Work Order ID 123594

Item ID: D205-596-107 Accept ***N900040100*** Setup Start ***NS1***
 Revision ID: Stop ***NS2***
 Item Name: Aft Crosstube - Extended Height 31"
 Start Date: 8/14/14 Start Qty: 1.00 ***1*** Cust Item ID:
 Required Date: 8/27/14 Req'd Qty: 1.00 ***1*** Customer:
 Reference:

DRAWING NO. D205-596-107	TITLE CROSSTUBE	REV. B	DART AEROSPACE LTD ENGINEERING ORDER	D.E.O. NO. D205-596-107-B-1	SHEET NO. SHEET 1 OF 1	SCALE NTS
DRAWN <i>AB</i>	CHECKED <i>PH</i>	MFG. APPR. <i>CE</i>	APPROVED <i>MD</i>	DE APPR. <i>#</i>		
DATE 09.05.01	DATE 09.05.15	DATE 09.06.15	DATE 09/06/16	DATE 09/06/16

DRAWING NO. D205-596-107	TITLE CROSSTUBE ASS'Y, HI-HI AFT	REV. B	DART AEROSPACE LTD ENGINEERING ORDER		D.E.O. NO. D205-596-107-B-2	SHEET NO. SHEET 1 OF 1	SCALE NTS
DRAWN <i>q</i>	CHECKED <i>A.P.</i>	MFG. APPR. <i>A</i>	APPROVED <i>MD</i>		DE APPR. <i>MD</i>		
DATE 13.11.11	DATE 13.11.19	DATE 13.11.19	DATE 13/11/21		DATE 13/11/21

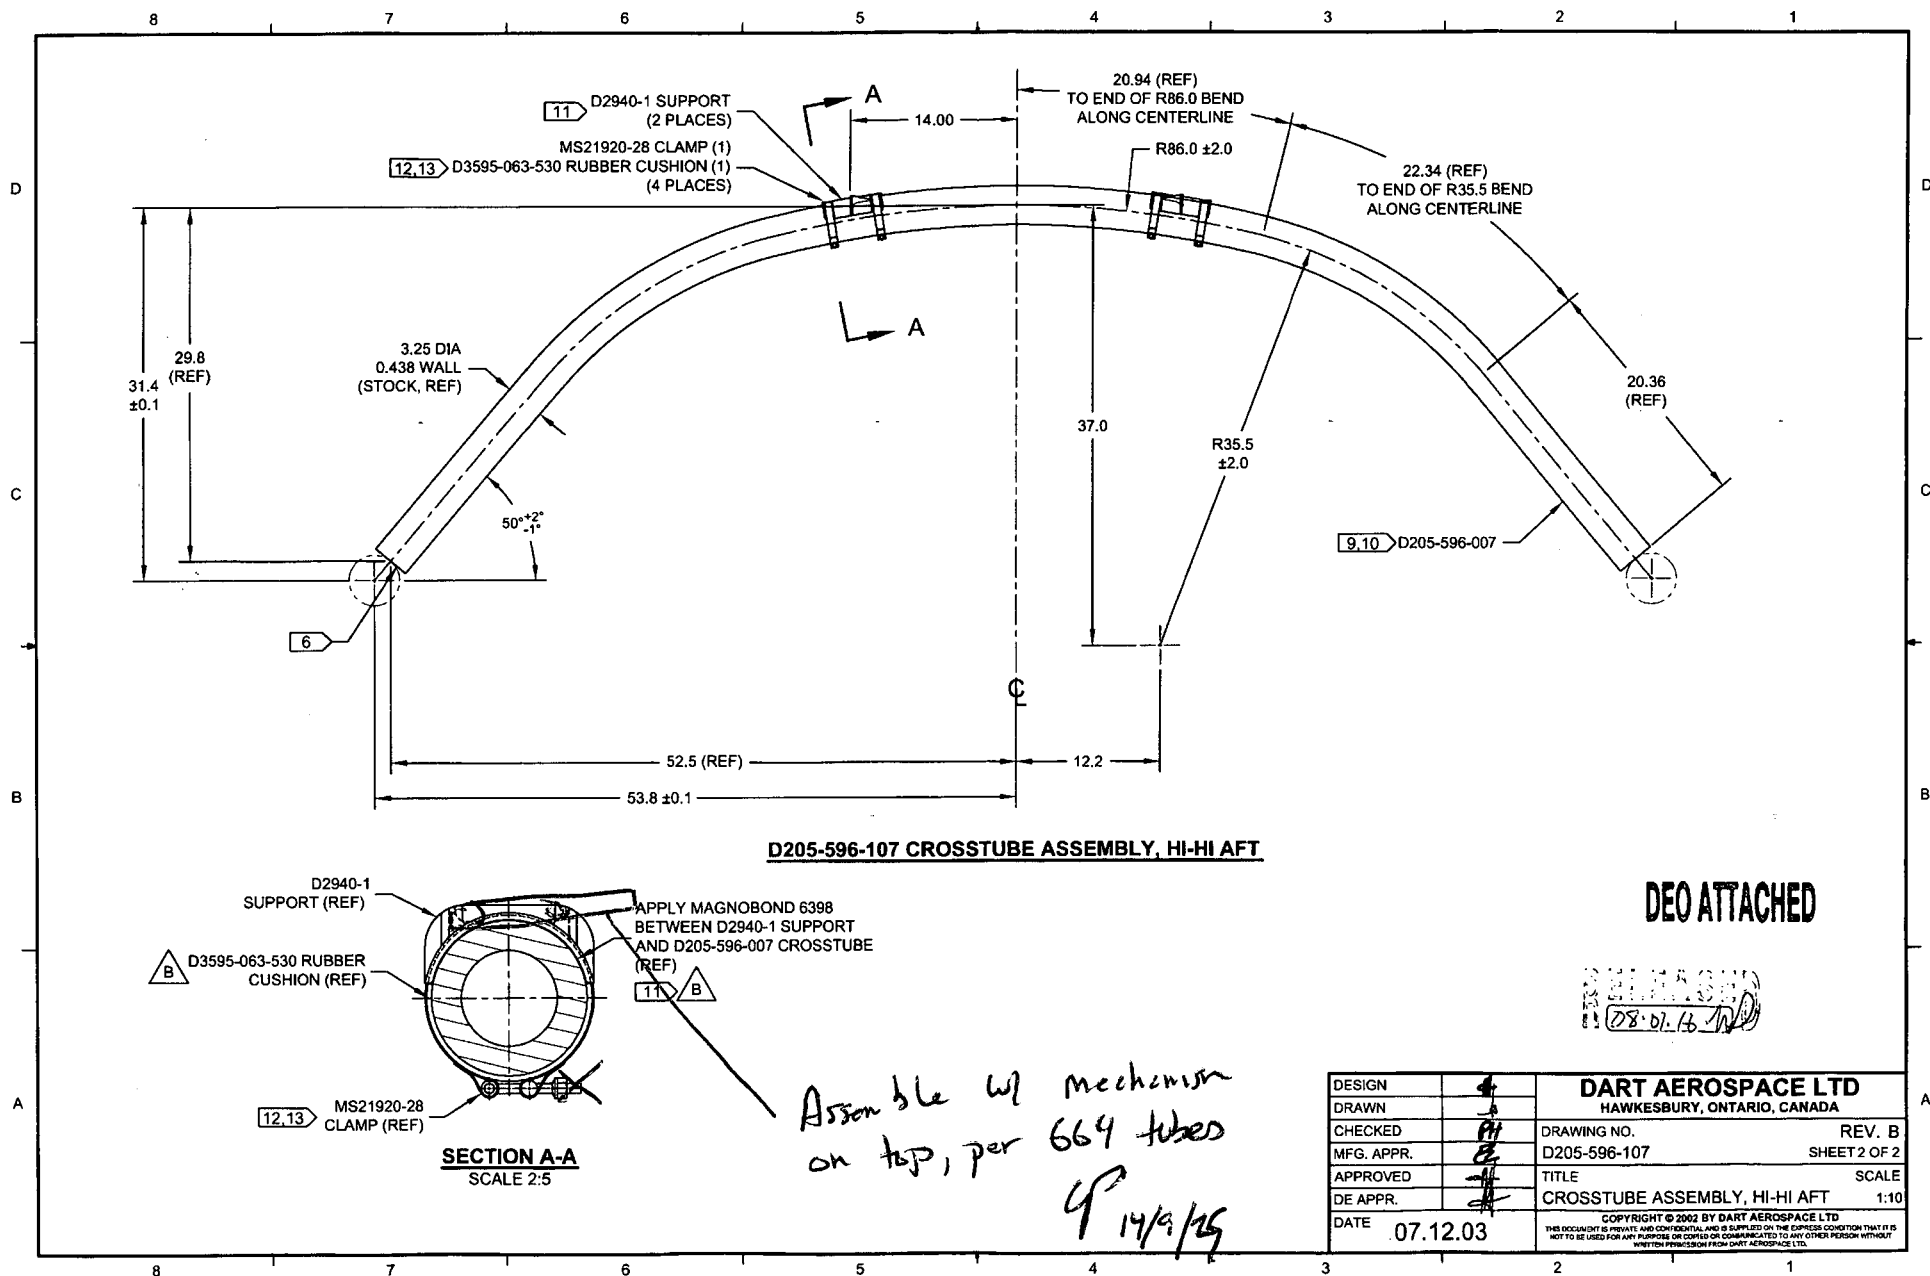
REPLACE MAGNOBOND WITH PROSEAL.

NOTE 11 & 13, SHEET 1 IS AMENDED AS FOLLOWS:

- 11) APPLY A 0.03" TO 0.06" THICK LAYER OF MAGNOBOND 6398 TO THE SURFACE OF D2940-1 THAT WILL BE IN CONTACT WITH THE CROSSTUBE. LET CURE FOR 12 HOURS AFTER INSTALLATION AND PRIOR TO PACKAGING.
- 13) TORQUE CLAMPS 80 TO 100 IN-LB.

- 11) TO INSTALL D2940-1 SUPPORT: ABRAD MATING SURFACE OF SUPPORT AND CROSSTUBE WITH 180-GRIT SANDPAPER AND REMOVE RESIDUE WITH MEK (OR EQUIVALENT). APPLY A 0.04" TO 0.07" THICK LAYER OF PROSEAL 890 CLASS B-2 (OR AMS-S-8802 CLASS B-2) SEALANT TO MATING SURFACE OF SUPPORT.
- 13) TORQUE CLAMPS 80 TO 100 IN-LB. ENSURE AT LEAST 1.5 THREADS SHOWING IN SAFETY AND THAT NUT HAS NOT BOTTOMED-OUT AFTER TORQUING. PRIOR TO PACKAGING, RE-CHECK TORQUE ON CLAMPS AFTER PROSEAL 890 SEALANT HAS CURED FOR 72 HOURS.

FIGURE 1 - SUPPORT INSTALLATION

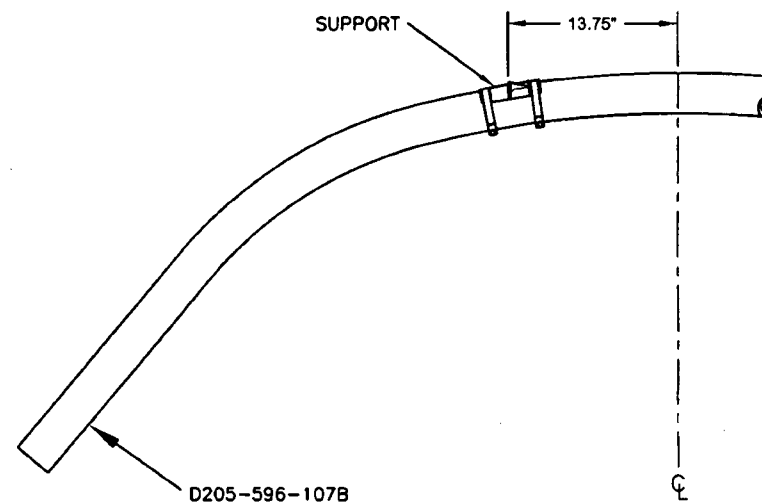
ADD THE FOLLOWING CROSSTUBE ASSEMBLY:

Part Number	Description
D205-596-107B	CROSSTUBE ASSEMBLY (214 HI-HI AFT)

THE D205-596-107B CROSSTUBE HAS THE SAME PARTS LIST AS THE D205-596-107 CROSSTUBE. HOWEVER, INSTALL THE SUPPORTS AS SHOWN IN FIGURE 1 OF THIS ENGINEERING ORDER. THE NEW KIT IS OTHERWISE ASSEMBLED PER THE D205-596-107 CROSSTUBE.
